1.1.1 Velocity Transport Planning (VTP) has been appointed by Rydon Homes Ltd to undertake a review of the Tunbridge Wells Borough Council (TWBC) submission Local Plan 2023 documents in order to provide a:

- ◉ Headline review of the documentation relating to the Five Oak Green Bypass to determine whether it is actually feasible/viable/necessary in the context of reduced development quantum and the removal of Tudeley; and a
- ◉ Headline review of the Colts Hill Bypass to determine whether it remains viable in context of reduced development quantum.

# TECHNICAL NOTE: FIVE OAK GREEN & COLTS HILL BYPASSES

Figure 2-1: Extract of Map 33 from TWBC Submission Local Plan 2020 – 2038 – Submitted October 2021

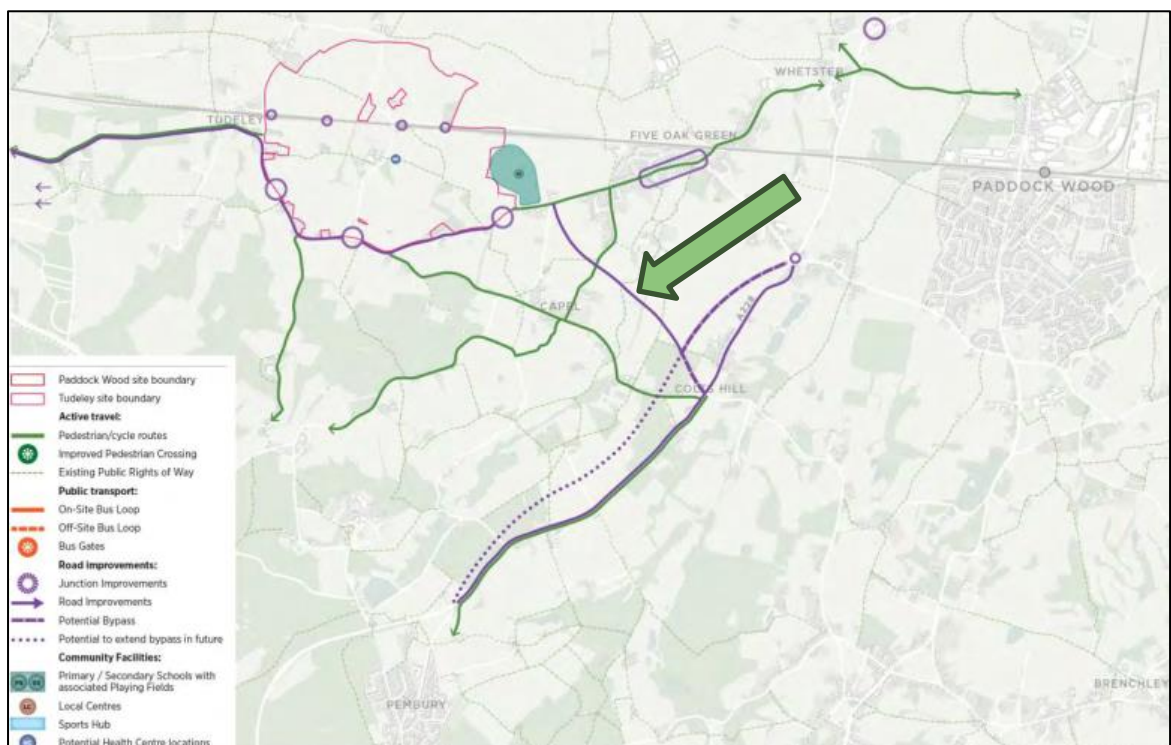
2.2.7 Schools are generally classed as sensitive receptors when it comes to air quality and noise, and therefore, it is considered the positioning of the roundabout adjacent to the school which would take traffic from the proposed bypass would have a significant impact on the school. The only way to mitigate this is by relocating the roundabout and the bypass alignment. However, this would only be possible if land was in the ownership of the developer or TWBC.

- 2.2.9 The Inspectors letter at paragraph 26 also related to pedestrian safety. The positioning of a roundabout adjacent to the school which also brings additional traffic directly to area in front of the school will increase the opportunities for conflicts between pedestrians and motor vehicles, and increase severance caused by vehicles. Further, the anticipated positioning of the roundabout based on the constraints of Capel School and the residential/office development adjacent to Five Oak Green Road/Church Lane would result in parents having to park further away from the school for the drop off and pick up of pupils. To mitigate this a car park or pick up/drop off area would need to be created next to the school but the land to do this would fall outside of the control of the council and or prospective developers. Therefore, it is considered that the locating of a roundabout with bypass in this location would have a severe impact on the safety and operation of the Capel School and the pupils attending it, and therefore it would not be acceptable in national transport policy terms.

- 2.2.12 Information on the delivery of the scheme in terms of compulsory purchase orders is not yet available for consideration. However, it is clear that if the land needed to deliver the Five Oak Green Bypass and the junctions at either end connecting it to the existing highway network is within multiple ownerships, there would be significant difficulties in obtaining the land required to build it, with significant costs that it is expected could not be justified without the provision of the 2,800 homes to be delivered by Tudeley Village. As such, it is considered that on the basis costs and difficulties in obtaining land to deliver the bypass and connecting junctions at either end, without the need warranted by Tudeley Village, (further details below) the feasibility of delivering the Five Oak Green Bypass would be extremely difficult.

2.4.3 It is therefore clear that the Five Oak Green Bypass is not considered to be necessary from a highway capacity perspective.

Figure 3-1: Extract of Map 33 from TWBC Submission Local Plan 2020 – 2038 – Submitted October 2021

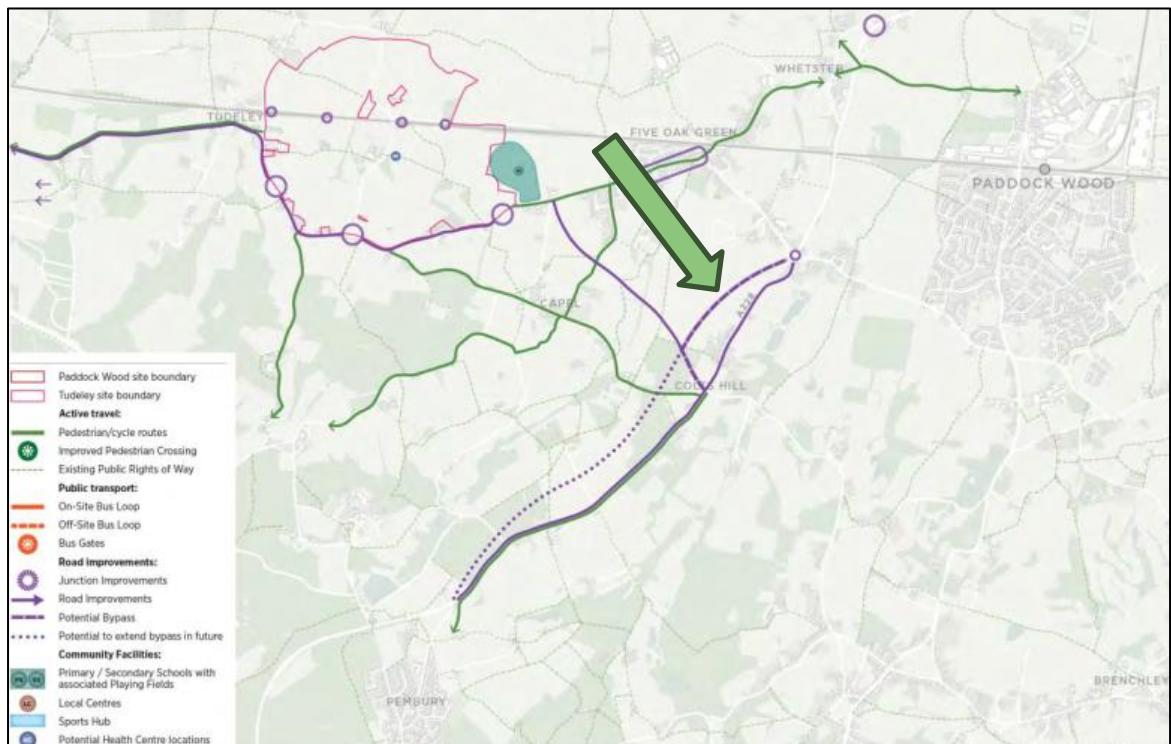
- 3.1.2 Further work undertaken since the Draft Local Plan has indicated that this entirely off-line route is not necessary to mitigate the impacts of strategic growth at Paddock Wood and east Capel, and at Tudeley Village. Instead, a part off-line new section of highway running to the north west of a collection of houses in Colts Hill on the A228, together with other on-line improvements to the A228 to the east, is proposed.

- 3.1.3 The indicative alignment of the Colts Hill Bypass is shown in **Figure 3-1** below as the purple dashed line running between the A228/B2017 roundabout in the north to the west of Colts Hill as indicated by the green arrow. The dotted purple line is the continuation of the route proposed by KCC which is now not proposed to come forward.

**Figure 3-2: Colts Hill Bypass – Extract of Stantec drawing 332410964-STN-HGN-SW-DR-H-0702**

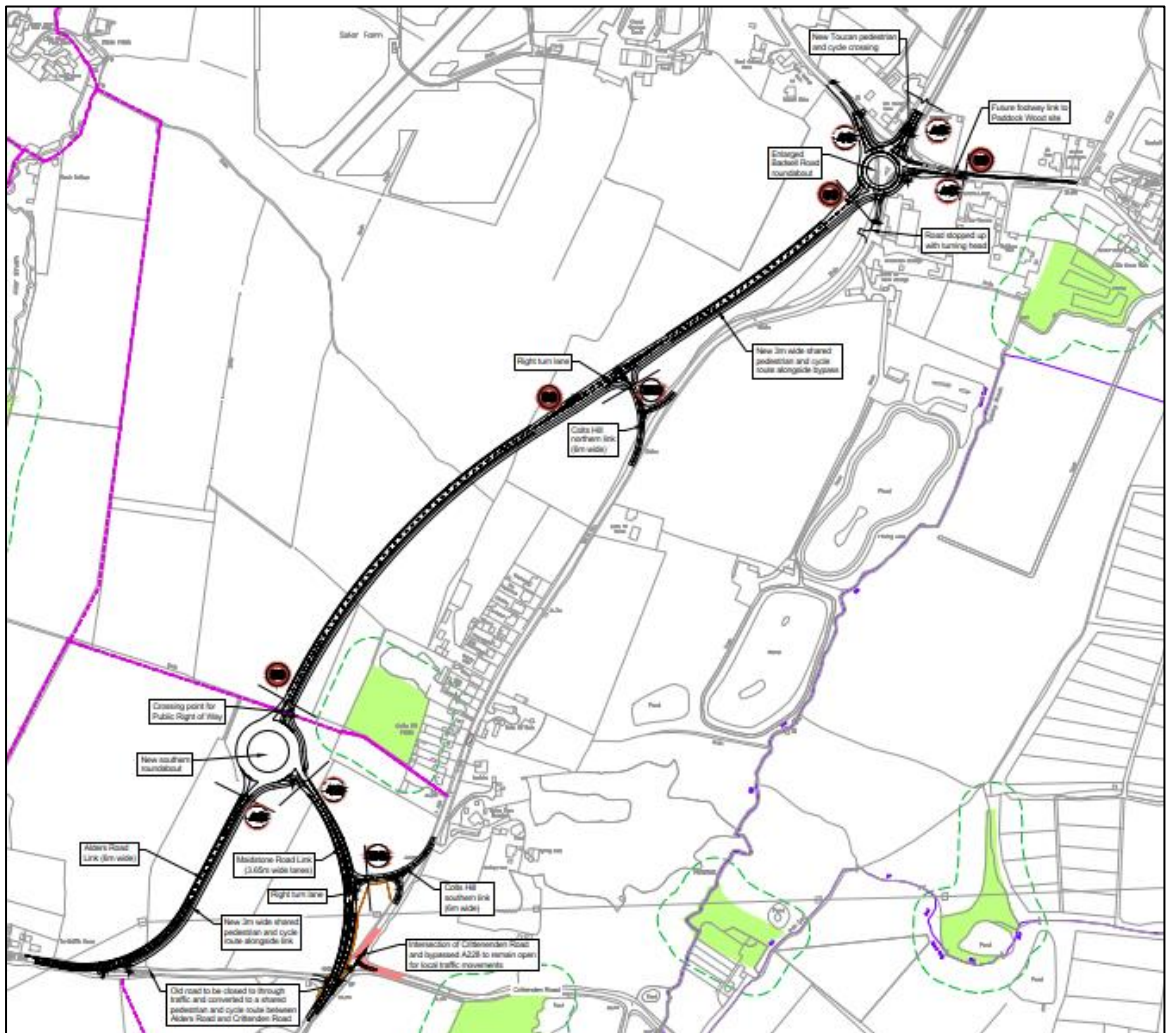
- 3.2.4 The indicative alignment of the Colts Hill Bypass indicates it would pass through at least one Public Right of Way and potentially multiple landownerships. Whilst TWBC could utilise compulsory purchase orders to obtain the land required, sections of land to the south/east of the link road would become unusable for farming due to their reduced size and access and therefore the land value would plummet for the existing owner. It is therefore considered appropriate compensation would be further required, possibly impacting on the viability of purchase and as such the feasibility to deliver the route.

- 3.2.5 Whilst Public Rights of Way could be stopped up or diverted with measures put in place to allow for safe crossing of the road, there would be lengthy consultation processes that could hinder the timescales of the delivery of the acceptability of the Local Plan

- 3.2.6 Information on the delivery of the scheme in terms of compulsory purchase orders is not yet available for consideration. However, it is clear that if the land needed to deliver the Colts Hill Bypass and the junctions at either end connecting it to the existing highway network is within multiple ownerships, there would be significant difficulties in obtaining the land required to build it. As such, it is considered that on the basis costs and difficulties in obtaining land to deliver the bypass and connecting junctions at either end, with fewer residential units planned at Paddock Wood and east Capel, the feasibility of delivering the Colts Hill Bypass would be extremely difficult.
